SUBJECT: ENVIRONMENTAL ASSESSMENT FOR LICENSE RENEWAL OF FANSTEEL, INC.,
MUSKOGEE, OKLAHOMA (TAC NO. L30705)

REQUEST FOR ADDITIONAL INFORMATION
FANSTEEL, INC., SOURCE MATERIAL LICENSE SMB-911
DOCKET 40-7580

SUBJECT: REQUEST FOR ADDITIONAL INFORMATION: PROCESSING RESIDUES
(TAC NO. L30756)

RESPONSE TO REQUEST FOR ADDITIONAL INFORMATION
REGARDING FANSTEEL'S LICENSE AMENDMENT REQUEST,
DATED 25 JANUARY 1995
DOCKET 40-7580

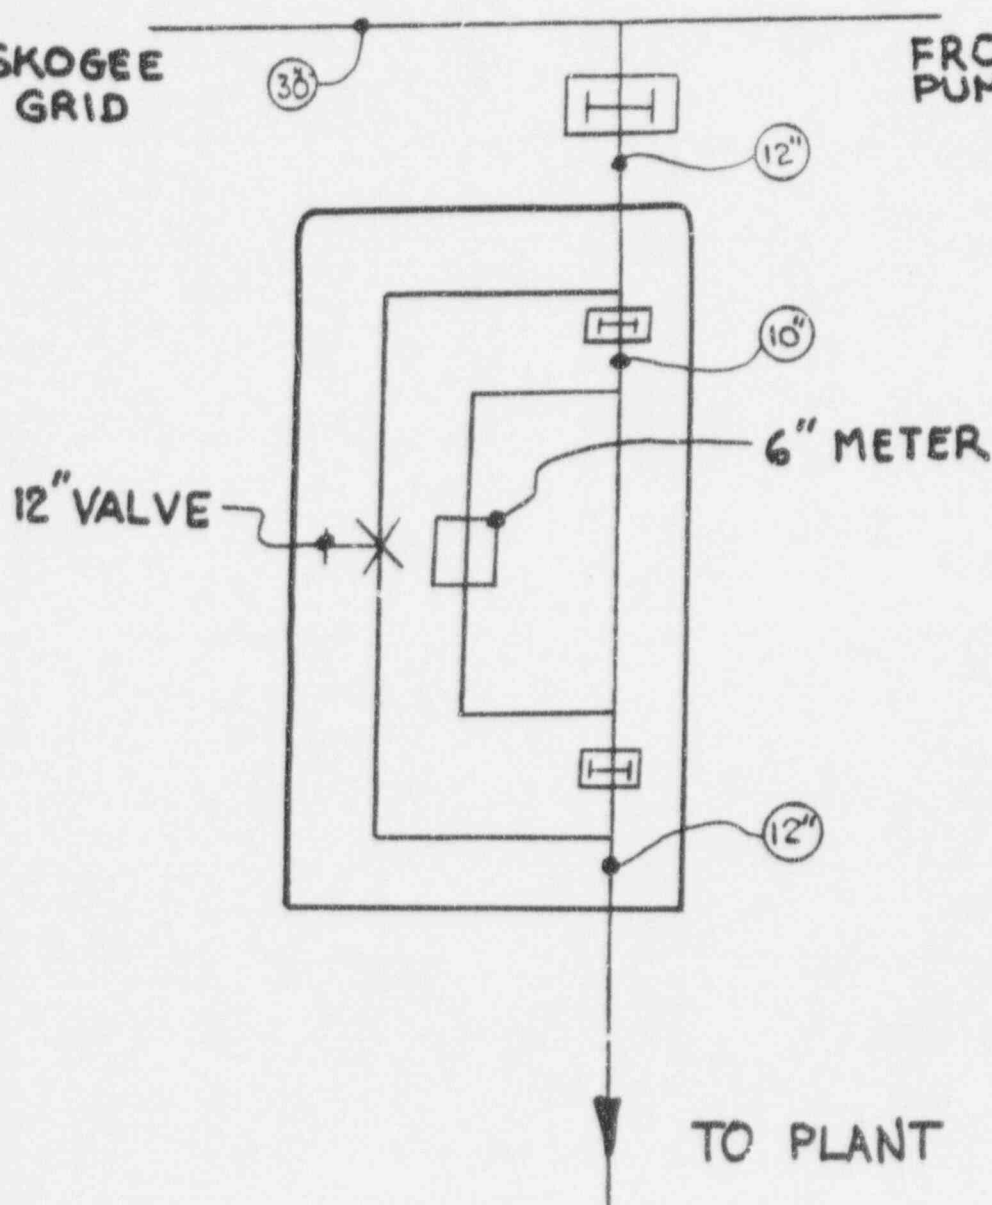
- 2.1 Describe any procedures established to ensure fire safety, which should include
 - a. An annual review by the management (or a Safety Committee) of the procedures and their implementation and a plant walk-down inspections at more frequent intervals,

FANSTEEL RESPONSE - The buildings in use for processing are constructed of either brick and steel or are metal sheeting over steel framing. When operating, the buildings will have smoke alarms for in-place detection and will have fire alarms secured through a constant surveillance system which are transmitted to the local fire department. The local fire department is familiarized annually with plant materials and operation. Updates are issued to the fire departments, as necessary.

Inasmuch as this is a rather small plant, the entire workforce will be trained in fire protection procedures at initial hiring and will be updated formally on an annual basis.

A community emergency plan, and a notification listing is in effect for all emergent conditions.

The plant had "hot work" procedures in effect prior to shutdown and these will be reenergized for the proposed process plant.

Maintenance of alarms, extinguishers and other fire safety equipment is done in accordance with national safety standards and manufacturer's recommendations.

The proposed plant will be a continuous operating plant. Personnel will be on site 24 hours a day. Management safety reviews will be done semi-annually on a formal basis and as often as required to keep personnel updated and working safely.

Enclosed are three figures describing the plant water and fire fighting system.
